Access Compliance Report

Public Rights-of-Way

(Curb Ramps)

Intersection ID: 12897	Main Street: ABBEYDALE_DR	Cross Street: WOODGREEN_TR	Location: NW
ADA ID: 766E440BD769	Ramp Type: BlendTrans2	Initial Pass/Fail: Fail	Overall Compliance: No
		Severity Score: 12.5

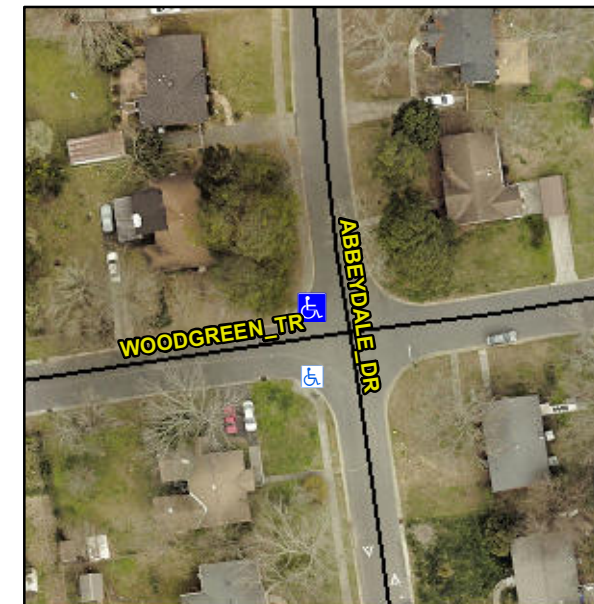
Not Found, R304.5.3

Compliance	Description	Data	Compliance	Description	Data
N/A	Ramp Length (in)	62.0	Yes	BlendTrans Slope (%)	3.7
Yes	Ramp Width (in)	67.0	No	BlendTrans XSlope (%)	5.8
N/A	Flare Type LT	N/A	N/A	Flare Type RT	N/A
N/A	Flare Slope LT (%)	N/A	N/A	Flare Slope RT (%)	N/A
N/A	Flare Traversable LT?	N/A	N/A	Flare Traversable RT?	N/A
N/A	Landing Length (in)	N/A	N/A	DWS Provided?	N/A
N/A	Landing Width (in)	N/A	N/A	DWS Contrast?	N/A
N/A	Landing Slope (%)	N/A	N/A	DWS Length (in)	N/A
N/A	Landing X Slope (%)	N/A	N/A	DWS Full Width?	N/A
N/A	Landing Curb? (Y/N)	N/A	N/A	DWS Offset (in)	N/A
N/A	Shared Landing?	N/A			
N/A	Gutter Ponding?	N/A	N/A	Gutter Slope (%)	N/A
N/A	Gutter Lip Ht (in)	N/A	N/A	Gutter X Slope (%)	N/A
N/A	Painted X Walk1?	No	N/A	Painted X Walk2?	N/A
	X Walk 1 Direction	To S		X Walk 2 Direction	N/A
	X Walk 1 Width (in)	N/A		X Walk 2 Width (in)	N/A
	X Walk 1 Slope (%)	1.3		X Walk 2 Slope (%)	N/A
	X Walk 1 X Slope (%)	7.0		X Walk 2 X Slope (%)	N/A

N/A	Ramp inside XWalk1?	N/A	N/A	Ramp inside XWalk2?	N/A
	Road Slope (%)	7.0		Clear Space?	N/A
	Road X Slope (%)	1.3	N/A	Clear Space to XWalk (in)	N/A
N/A	Any Obstructions?	N/A	N/A	Storm Grate/Utility Hazard?	N/A
	Obstruction Type			Storm Grate/Utility Type	
		N/A			N/A
			Yes	Surface Condition? (G/P)	Good
			No	Curb Slope (%)	7.1

Remove & Replace Curb Ramp With Two New Directional Ramps or Equivalent.
